Memorandum to the City of Markham Committee of Adjustment

File: A/024/21
Address: 1 Peter St Markham
Applicant: Zhifei Hu & Chunyan Yang
Agent: David Johnston Architect Ltd. (David Johnston)
Hearing Date: Wednesday April 21, 2021

as it relates to a proposed 2-Storey addition to an existing Heritage House.

FIGURE 3- PROPOSED WEST & SOUTH ELEVATIONS

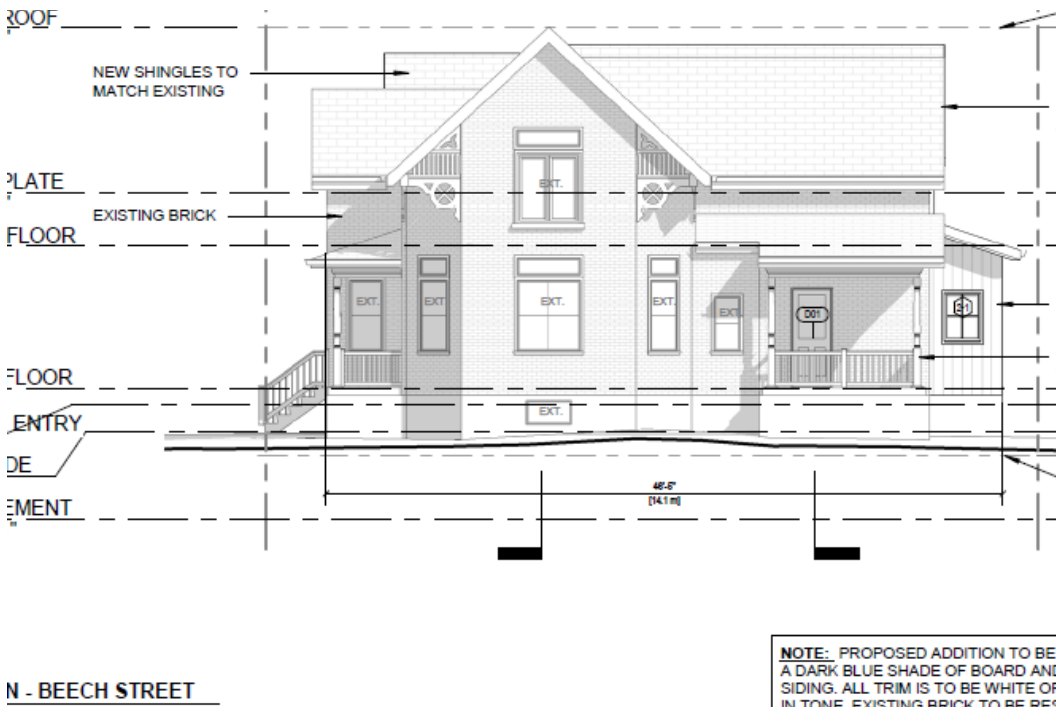
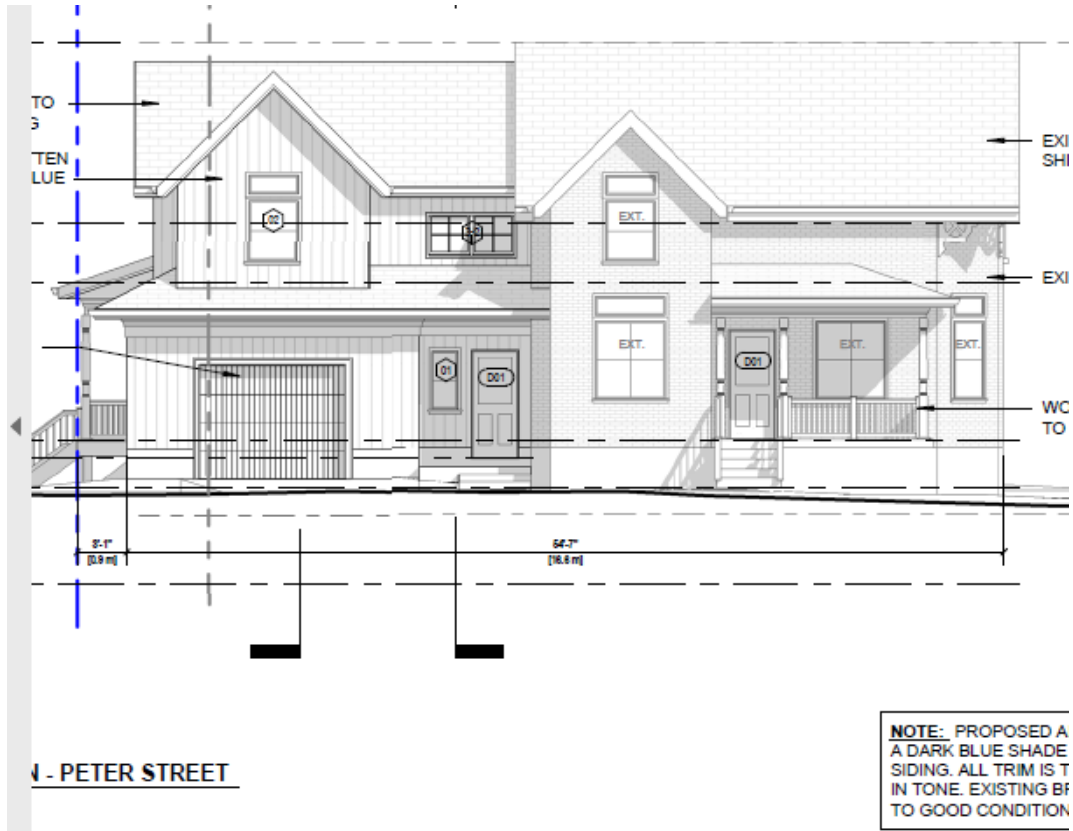
The owner is also proposing to reopen/restore historic verandas facing both Peter and Beech Streets that were enclosed by previous owners which will re-introduce these important architectural features and enhance the heritage character of the home. The owner also proposes to reopen a historic window opening that was closed off to permit

the installation of a modern fireplace and chimney (See Figure 3- Proposed West and South Elevations).

It should be noted that the drawings accompanying the variance application propose to restore important character defining features of the historic house including the re-opening of two street facing verandas and a historic window opening. Furthermore, the proposed addition is to be attached on the least significant non street facing facades of the existing heritage house and is more compatible in scale materials, form and architectural details than past non-heritage additions that are proposed to be removed as part of the project.

FIGURE 4- PROPOSED SITE PLAN

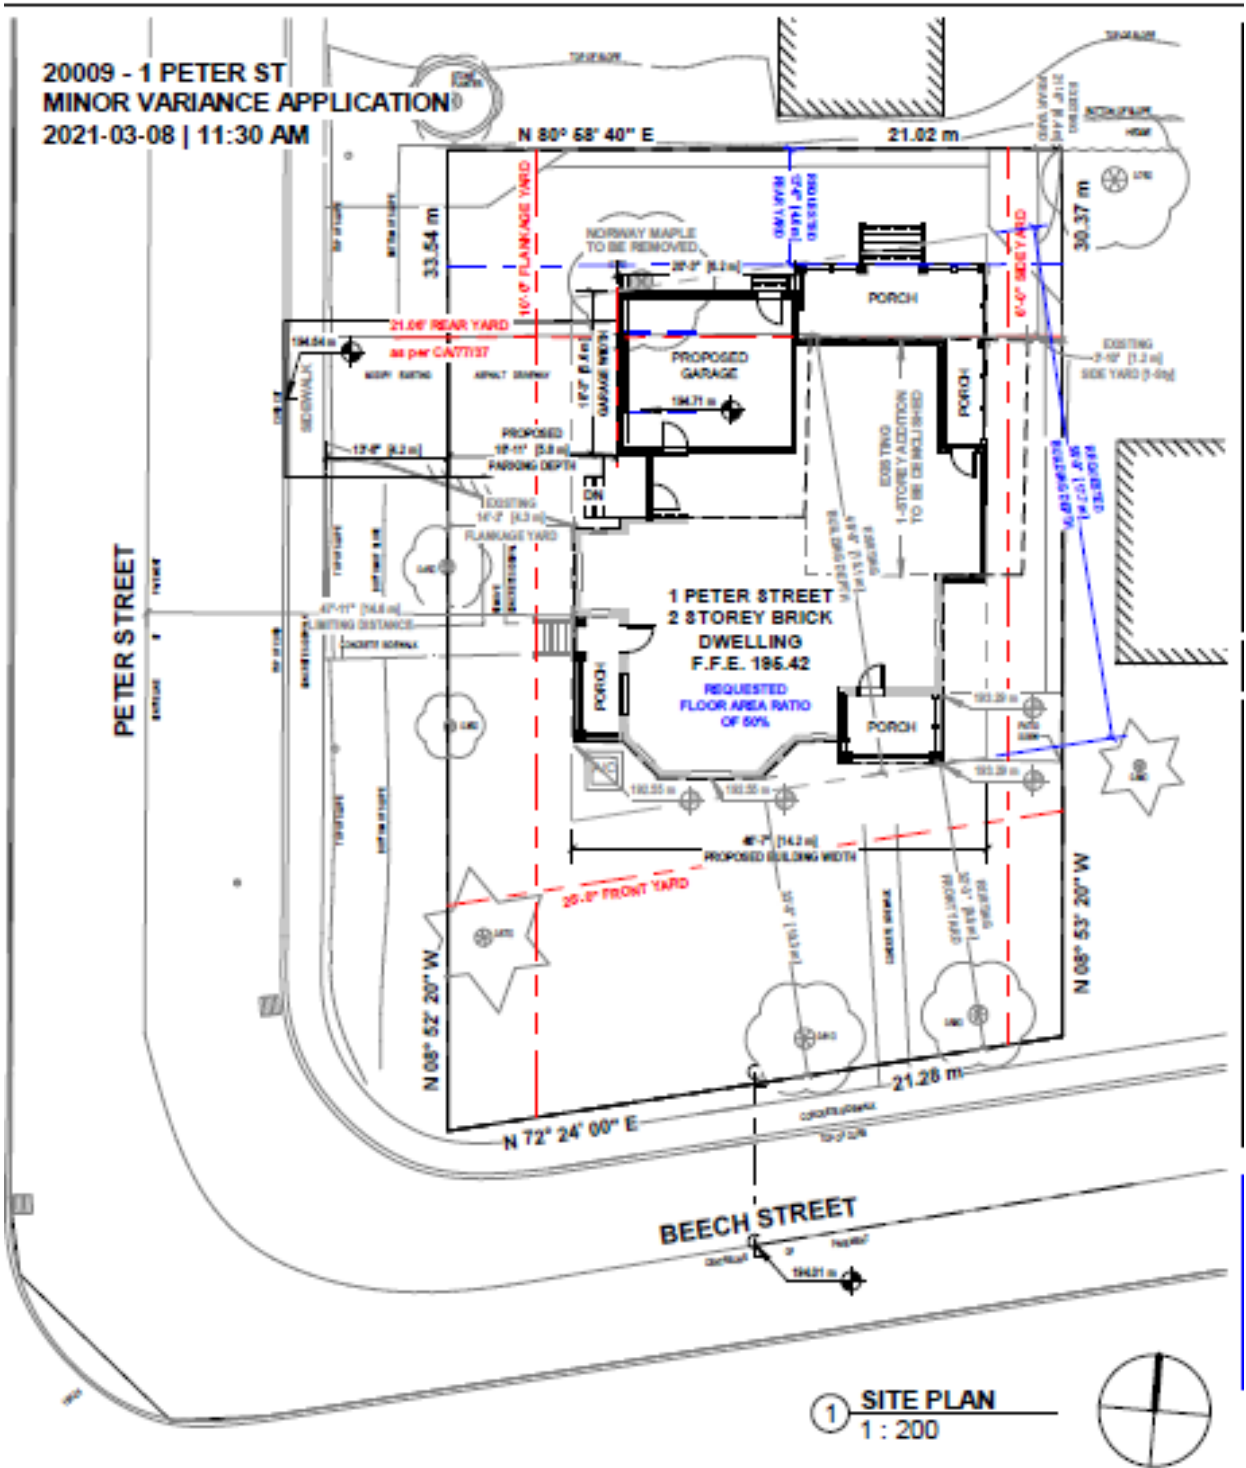
As the existing house is located on a corner lot, the front of the property from a zoning perspective is the narrowest street frontage, which is Beech Street, and the rear yard is the space between the proposed addition and the neighbouring property to the north. Therefore, the building depth represents the proposed width of the house on the Peter Street frontage, and the rear yard actually functions as a side yard from the vantage point of Peter Street (See Figure 4- Proposed Site Plan)

Although the requested variance to permit a reduction in the rear yard setback from 25 ft. to 13 ft. may seem significant, it is not considering that the minimum required side yard setback for a two storey dwelling required by the same By-law is 6 ft. When viewed as a side yard, which is how this area functions in reality, the proposed addition maintains a side yard setback from the neighbouring property that is more than twice the distance required by the By-law.
